Access Compliance Report

Public Rights-of-Way

(Curb Ramps)

Intersection ID: N/A	Main Street: MONROE_RD	Cross Street: N/A	Location: NW
ADA ID: D5D0D6033789	Ramp Type: PerpDiag	Initial Pass/Fail: Fail	Overall Compliance: No
			Severity Score: 13.75

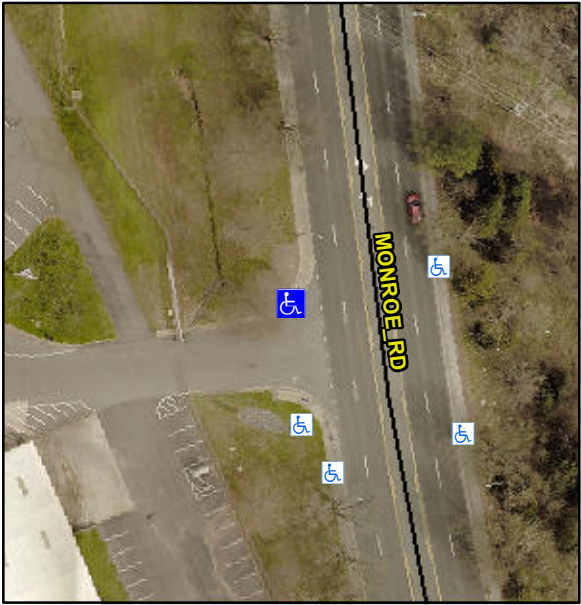
Codes/Mitigation Info/Possible Solution			Field Measurements/Component Compliance			
	Possible Solutions:		Compliance	Description	Data	
	Remove & Replace Curb Ramp With Two New Directional Ramps or Equivalent.		N/A	Ramp Length (in)	60.0	No
			Yes	Ramp Width (in)	48.0	No
			N/A	Flare Type LT	N/A	N/A
			N/A	Flare Slope LT (%)	N/A	N/A
			N/A	Flare Traversable LT?	N/A	N/A
			N/A	Landing Length (in)	N/A	N/A
			N/A	Landing Width (in)	N/A	N/A
			N/A	Landing Slope (%)	N/A	N/A
			N/A	Landing X Slope (%)	N/A	N/A
			N/A	Landing Curb? (Y/N)	N/A	N/A
			N/A	Shared Landing?	N/A	
			N/A	Gutter Ponding?	N/A	N/A
			N/A	Gutter Lip Ht (in)	N/A	N/A
			N/A	Painted X Walk1?	No	N/A
				X Walk 1 Direction	To S	X Walk 2 Direction
			N/A	X Walk 1 Width (in)	N/A	N/A
				X Walk 1 Slope (%)	1.8	X Walk 2 Slope (%)
				X Walk 1 X Slope (%)	1.9	X Walk 2 X Slope (%)
			N/A	Ramp inside XWalk1?	N/A	N/A
				Road Slope (%)	3.0	N/A
				Road X Slope (%)	0.6	N/A

N/A	Any Obstructions?	N/A	N/A
				Obstruction Type		Storm Grate/Utility Hazard?
						Storm Grate/Utility Type
					N/A	N/A
					Yes	Surface Condition? (G/P)
						Good

Not Found, R304.2.2, R304.5.3

Remove & Replace Curb Ramp With Two New Directional Ramps or Equivalent.
